Draft Greater Geelong Planning Scheme
Amendment C450ggee
Creamery Road Precinct Structure Plan and
Development Contributions Plan

**Northern and Western Geelong Growth Areas Standing Advisory Committee
Referral 2 Report – Volume 1**

1 July 2026

Figure 1 Council's Final Future Urban Structure Plan for the precinct

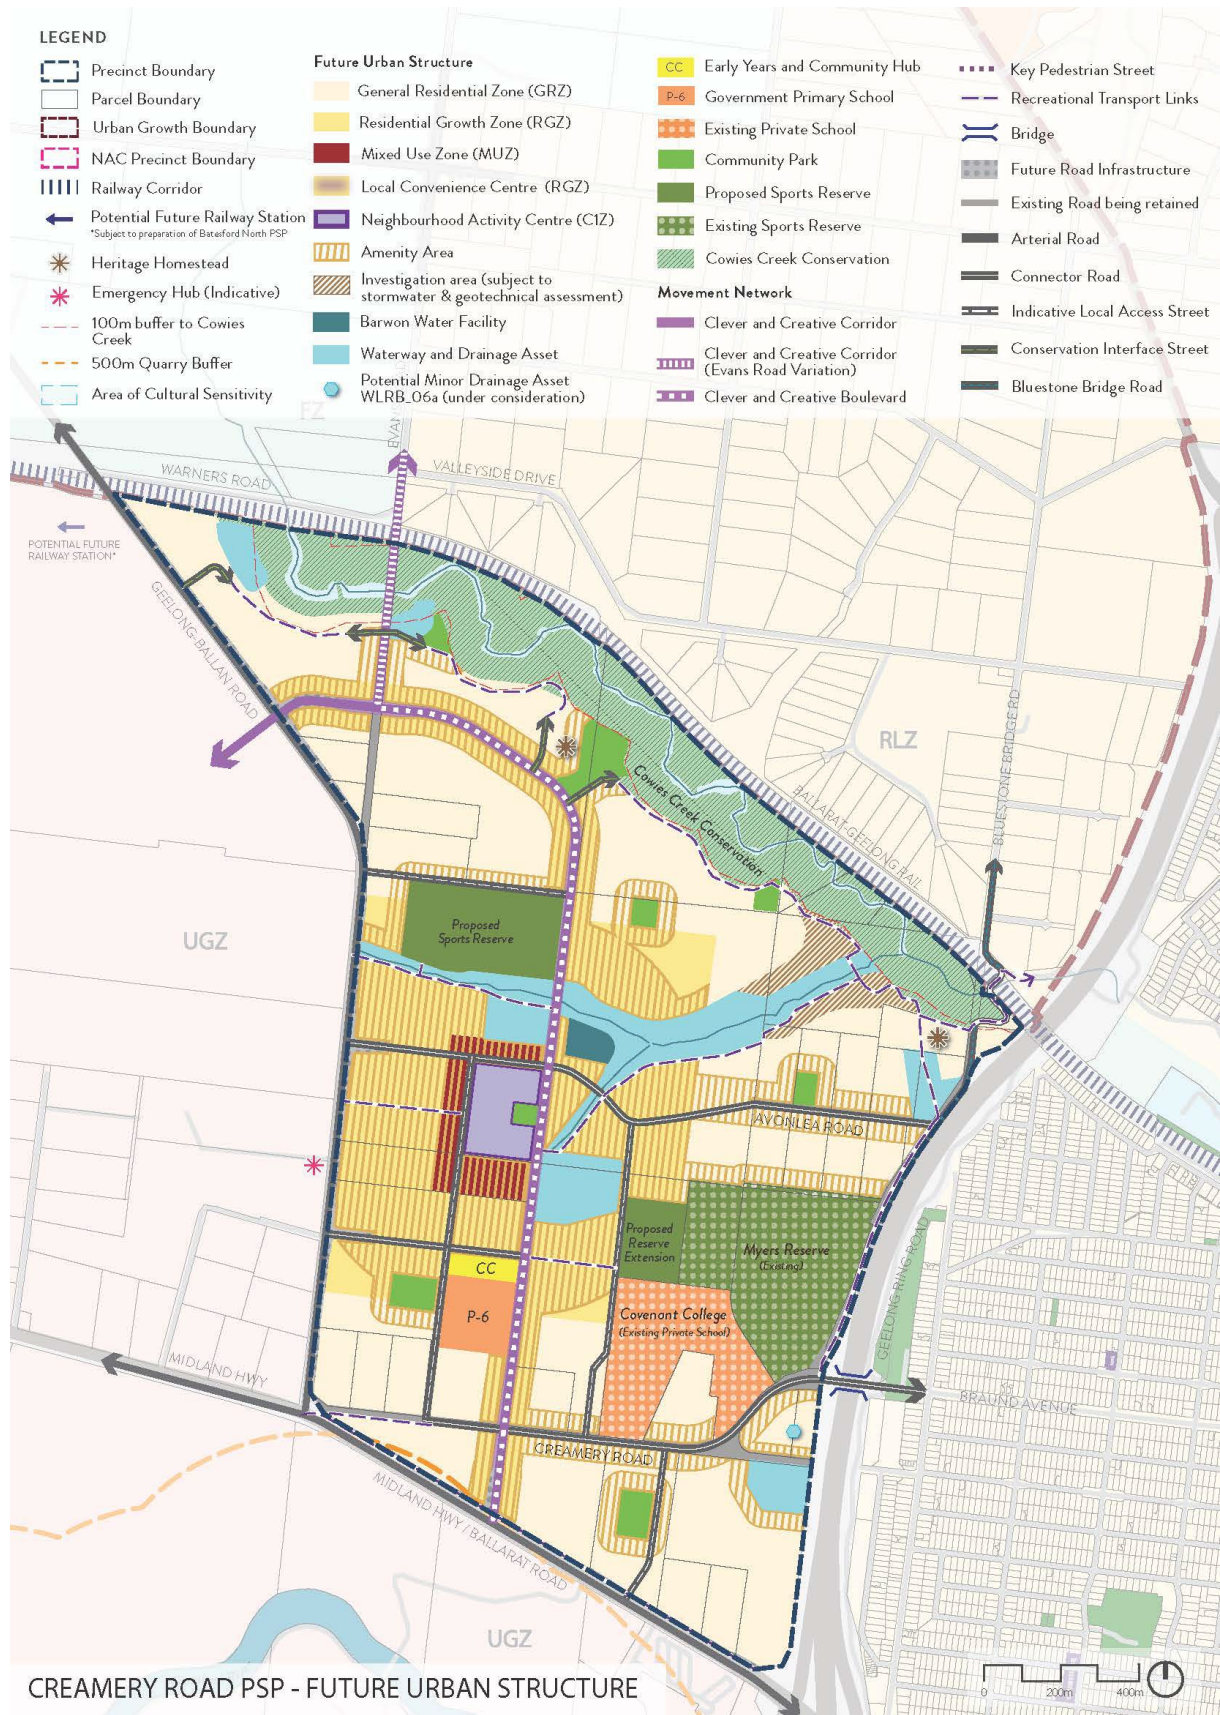
The Committee supports the location and size of the NAC as shown on Council's Final Future Urban Structure Plan. The NAC should be located on the corner of the east-west connector road and the Clever and Creative Boulevard (CCB) and have an area of 4 hectares. This location will meet the broader strategic objectives for the precinct and best serve the needs of future communities within the precinct.

The Committee found that the size, configuration and location of Basin 6 and Basin 7 as shown on the Council's Final Future Urban Structure Plan is appropriate.

It is appropriate to accommodate a split basin arrangement at Basin 6, however no change is required on the Future Urban Structure Plan.

Basin 7 can be redesigned as a sediment basin to reduce the size and cost of the asset. This may result in a change to the Future Urban Structure Plan – but the nature of the

change will need to be confirmed once the design is settled, as such no change to the Future Urban Structure Plan at this time.

- 1. Amend the Final Creamery Road Future Urban Structure Plan (Document 126) as follows:**
 - a) Show the northern and southern Local Convenience Centres in the locations on the Exhibited Future Urban Structure Plan, and at a size of 1,000 square metres each.**

- b) Retain Community Parks 6 and 7 as one-hectare parks.**
 - c) Show a 'potential' left-in/left-out intersection on Midland Highway between Geelong Ballan Road and the Clever and Creative Boulevard, with an access street extending north to Creamery Road.**

- f) Delete the red line described as '100-metre buffer to Cowies Creek'.**

Figure 7 Preferred NAC location in the Council Plan

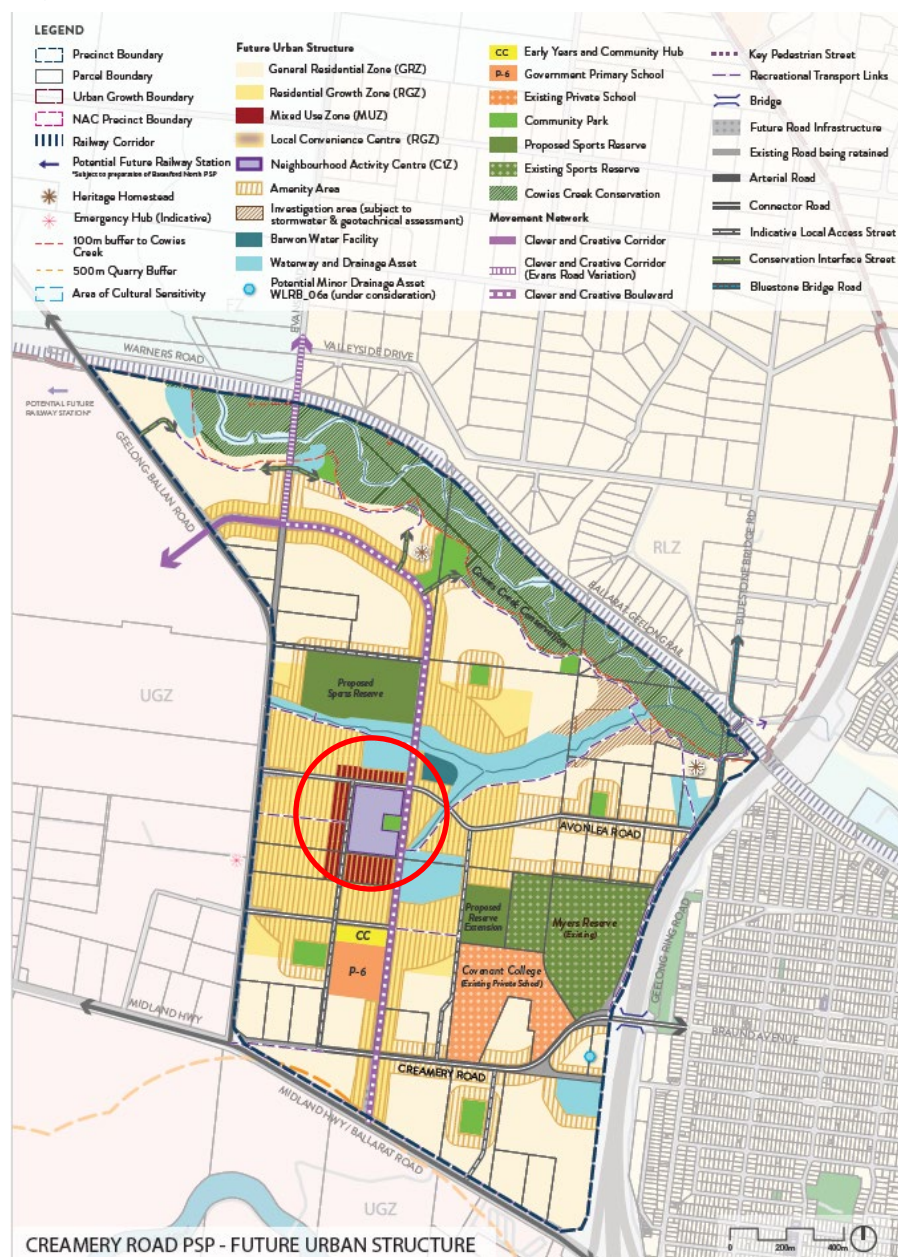
Council's Final Future Urban Structure Plan (the Council Plan, Figure 7) shows the NAC on the corner of the east-west connector road and the CCB.

Figure 8 Villawood preferred NAC location

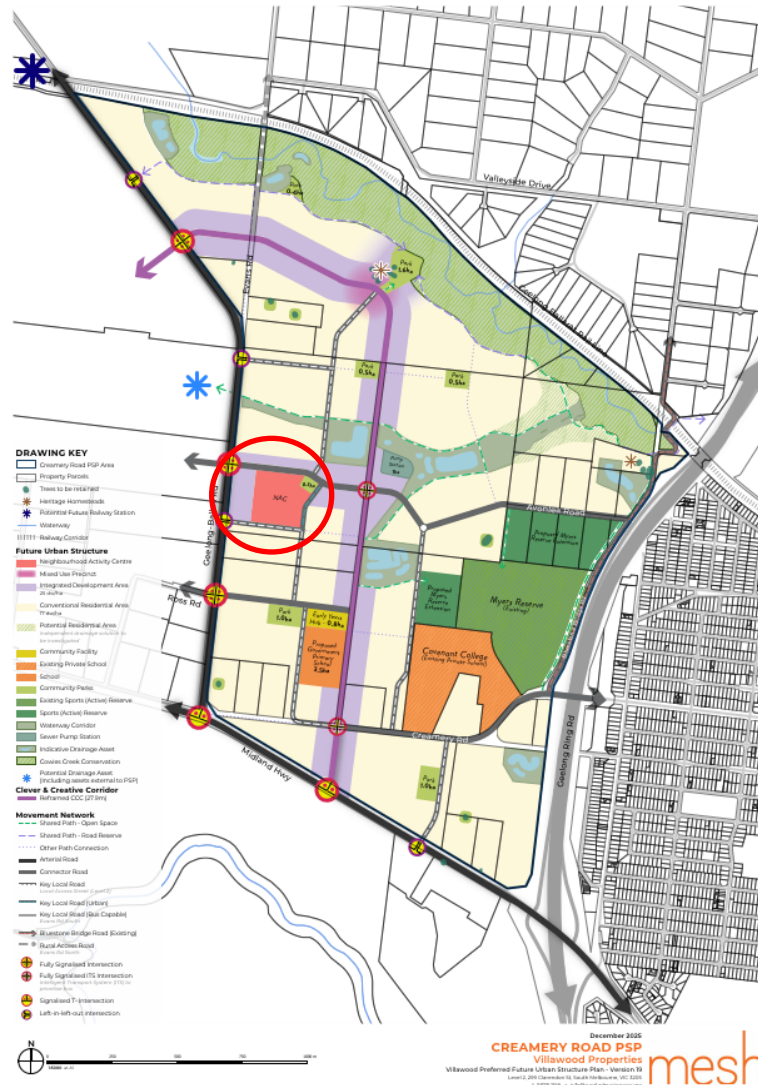
Villawood’s proposed alternative Future Urban Structure Plan (the Villawood Plan, Figure 8) shows the NAC located 200 metres to the west, in between the CCB and Geelong-Ballan Road.

Figure 9 LCCs in the Exhibited Future Urban Structure Plan

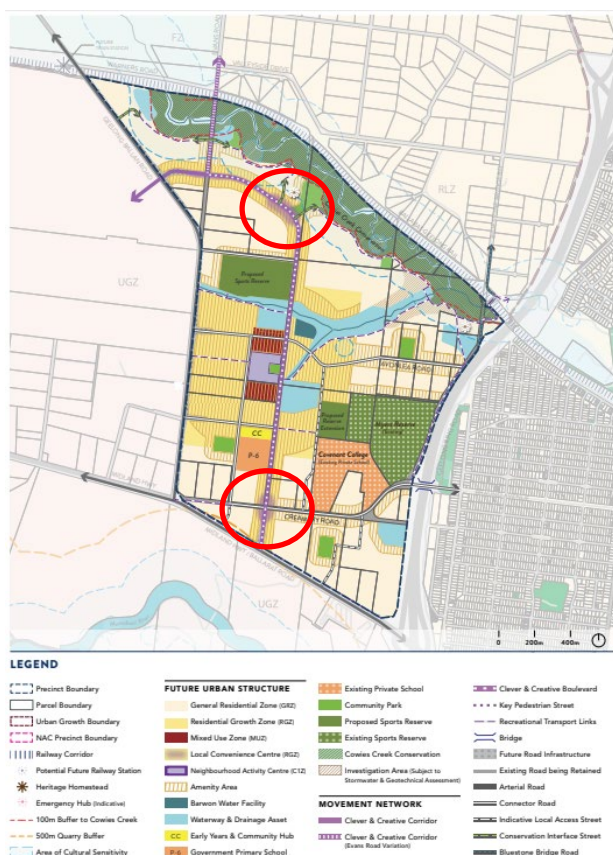
The Exhibited Future Urban Structure Plan showed two LCCs.

Figure 16 Final Future Urban Structure Plan – Transport network issues

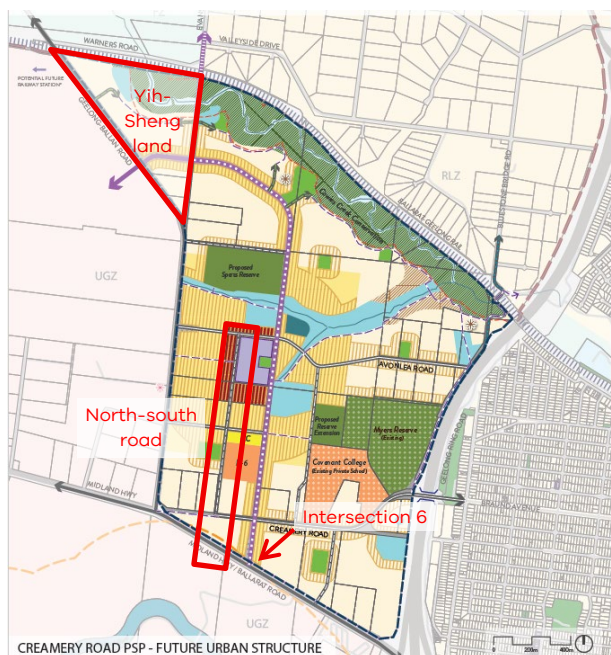
In its Final Future Urban Structure Plan, Council changed the north-south road to an access street to the north of Creamery Road and deleted the section to the south of Creamery Road (see Figure 16).

Figure 18 Plan included in EPBC Act approval for Yih-Sheng land

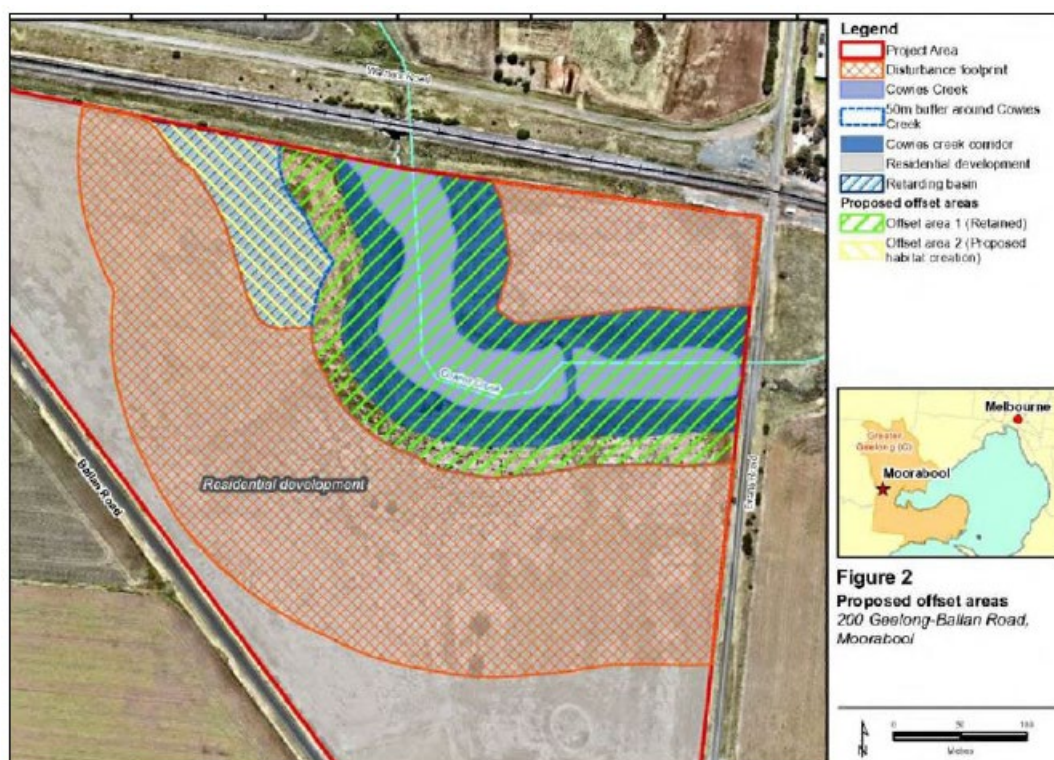
On the Yih-Sheng land, the Committee supports a narrower buffer to the south of Cowies Creek, generally aligning with the EPBC Act approval for that land. The Committee does not support a change to the buffer to the north of Cowies Creek. Based on the information currently available, it would be premature to designate the land in the north-eastern corner of the Yih-Sheng land as developable. However, the Committee recommends the Future Urban Structure Plans should identify this as an area for further investigation.

A site-specific Part 9 EPBC Act approval was granted for the land at 200 Geelong-Ballan Road, Moorabool (Yih-Sheng land). The EPBC Act approval allows a 50-metre buffer along Cowies Creek (measured from the centreline of the creek, as shown in Figure 18), a distance that is inconsistent with the 100-metre buffer proposed more generally across the precinct. The EPBC Act approval includes other conditions.

Figure 19 Creek buffer extent as shown in Council's Final Future Urban Structure Plan

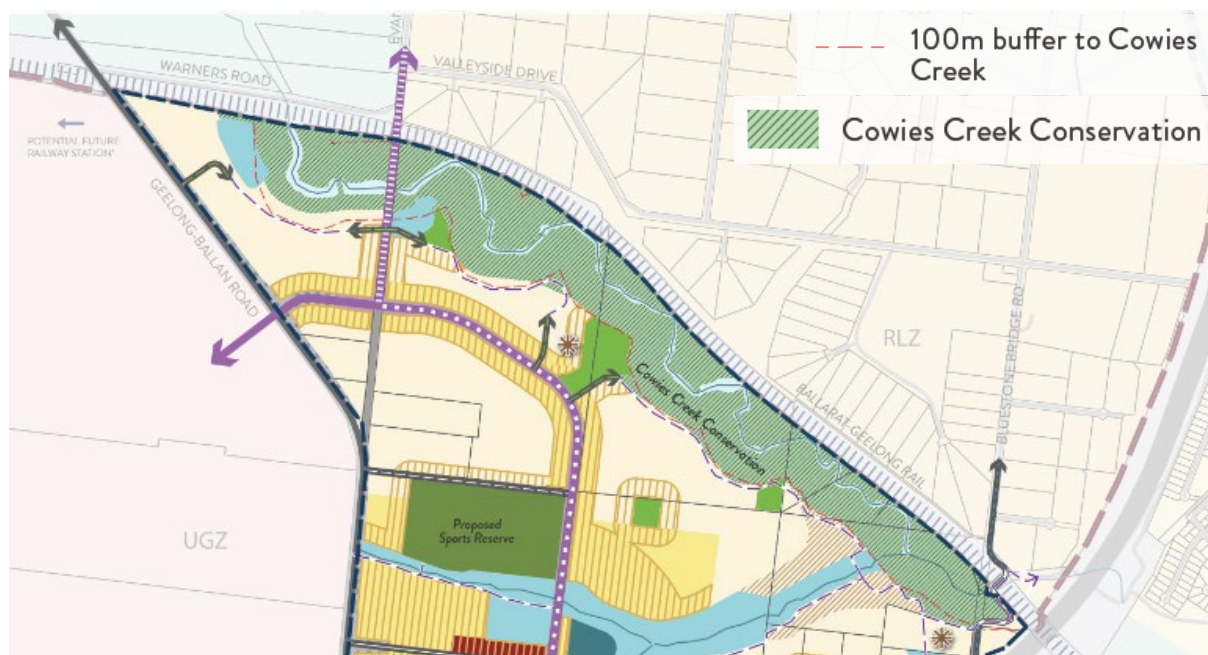
- The 100-metre buffer line (red line) on the Future Urban Structure Plan should be retained as it is indicative only.
- Basin 8 should not encroach on EPBC Act offset area 2 and should not be resized, as micro siting and sizing are matters for detailed design.
- Its final position on the creek buffer extent is reflected in the Final Future Urban Structure Plan shown in Figure 19.

Figure 9-1: Indicative minimising of BR 01 length of bridge

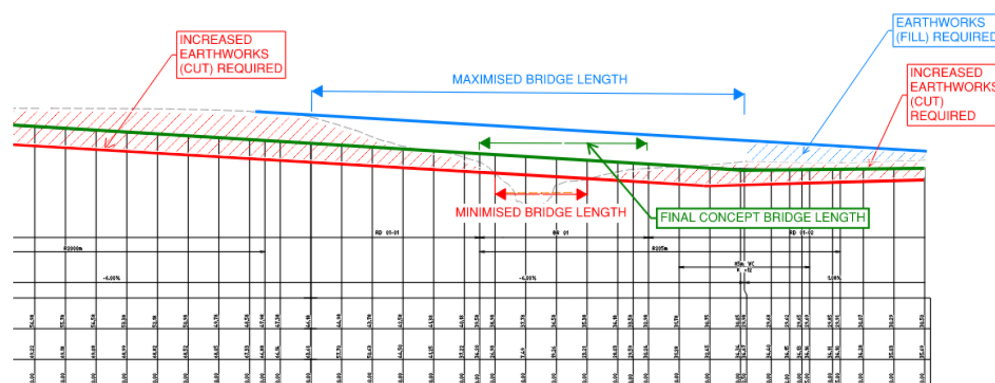
This approach, as outlined in Section 6.8, has resulted in one of the approaches, the northern approach to bridge BR-01, requiring a significant amount (when compared to all other approaches) of cut / earthworks below the existing surface to tie the road into the proposed bridge location, as shown through the green line in Figure 9-1 (alternative options that minimize the earthworks or bridge are also shown in Figure 9-1, as the blue and red dashed lines, respectively).

With reference to the Figure 9-1 above, the level of cut for the northern approach to bridge BR-01 (which was adjusted to 516m through the design process) accounts for the majority of the required earth works prior to where the road adopts a level of cut closer to the average 1,000 cubic meters of cut per meter.
